UNITED STATES PATENT AND TRADEMARK OFFICE

APPLICATION NO.	FILING DATE	FIRST NAMED INVENTOR	ATTORNEY DOCKET NO.	CONFIRMATION NO.
10/590,438	08/23/2006	Tsuneo Nakata	P/2054-140	8750
2352	7590	06/16/2010	EXAMINER	
OSTROLENK FABER GERB & SOFFEN 1180 AVENUE OF THE AMERICAS NEW YORK, NY 100368403				NGUYEN, DUC M
ART UNIT		PAPER NUMBER		
2618				
		MAIL DATE		DELIVERY MODE
		06/16/2010		PAPER

Office Action Summary	Application No.	Applicant(s)	
	10/590,438	NAKATA ET AL.	
	Examiner	Art Unit	
	DUC M. NGUYEN	2618

DETAILED ACTION

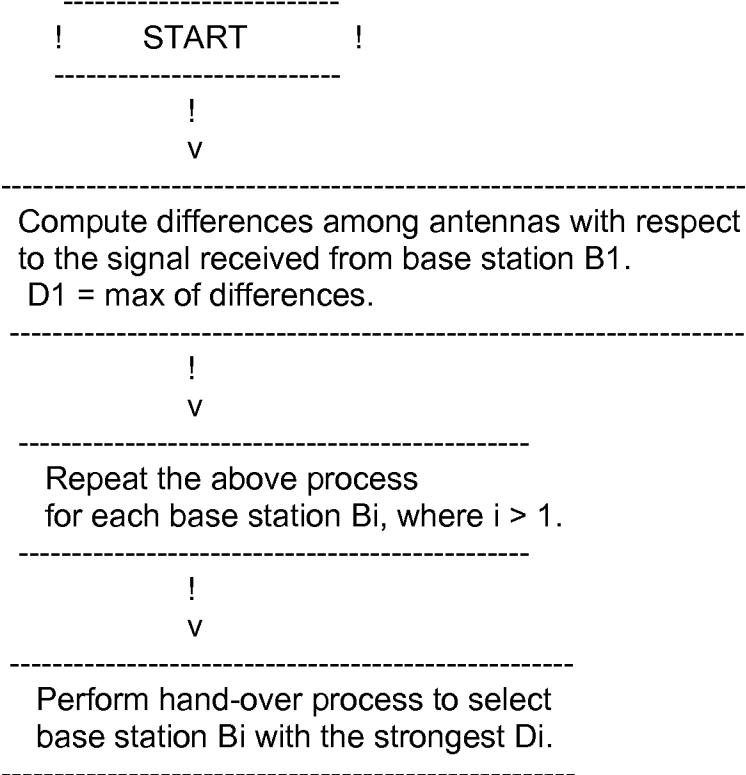
However, an amended specification and a new drawing showing a flow chart that would outline/detail all of the above procedures (i.e, step by step) would be required in order to overcome the 112 rejection below. This requirement must be met in order to conform to the requirement "The specification shall contain a written description of the invention, and of the manner and process of making and using it, in such **full, clear, concise, and exact terms** as to enable any person skilled in the art to which it pertains,

In addition, the limitation "a hand-over process based upon difference of said transmission/reception state of **each of** said antennas" as recited in claims 23, 28, 33, 38 should be changed to "a hand-over process based upon differences of said transmission/reception state of said antennas". This would clear up the **confusion** caused by "**each of**" terminology that the limitation "a hand-over process based upon difference of said transmission/reception state of **each of** said antennas" would imply, for example, the difference of B1 and B2 signals received at antenna A1 or the difference of B1 and B2 signals received at antenna A2.

2. The drawings are objected to under 37 CFR 1.83(a). The drawings must show every feature of the invention specified in the claims. Therefore, the "a hand-over process based upon difference of said transmission/reception state of each of said antennas" as recited in claims 23, 28, 33 must be shown ((i.e, details of a hand-off procedure) or the feature(s) canceled from the claim(s). No new matter should be entered.

A simple drawing is **proposed** below according to the statement "it is the difference in the sensing of the same signal between the two antennas that determines which particular base station will be selected,

Also note that an amended specification that describes the proposed drawing should also be included in the amendment.
